Oxfordshire County Council

Consultation Report:

Witney Local Cycling and Walking Infrastructure Plan

March 2023

Figure 2.2 – Location of proposed active travel Improvements as identified within the LCWIP for the North Witney area

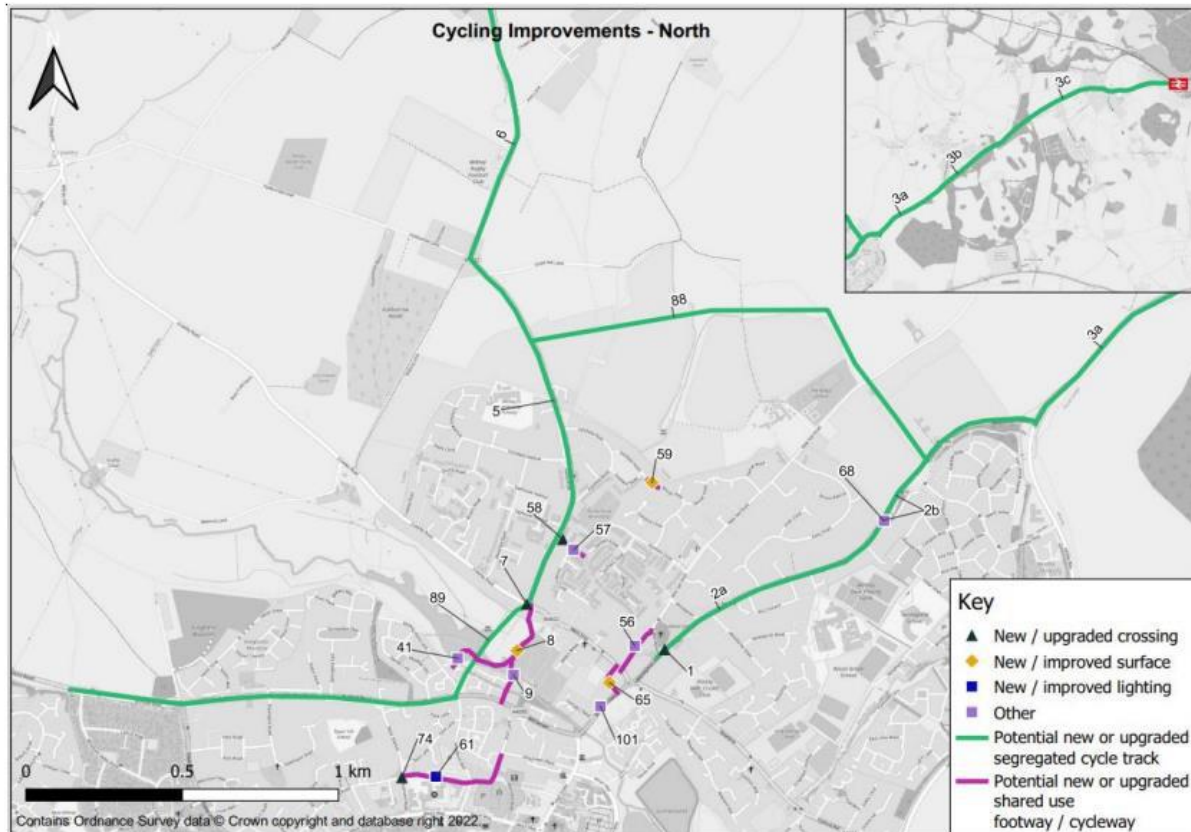
2.8 It can be seen from the above that there are a number of enhancements proposed in the North Witney area that include upgraded crossing points, improved surface and lighting and potential new or upgraded cycle track and shared use footway / cycleway. A summary of the detail of each of these enhancements is provided in **Table 2.1** below. The information in **Table 2.1** also includes an additional identified walking enhancement (listed as item 82) which is not shown on the diagram in **Figure 2.1** but is located within the North Witney area and on the desire line from the North Witney SDA into Witney.
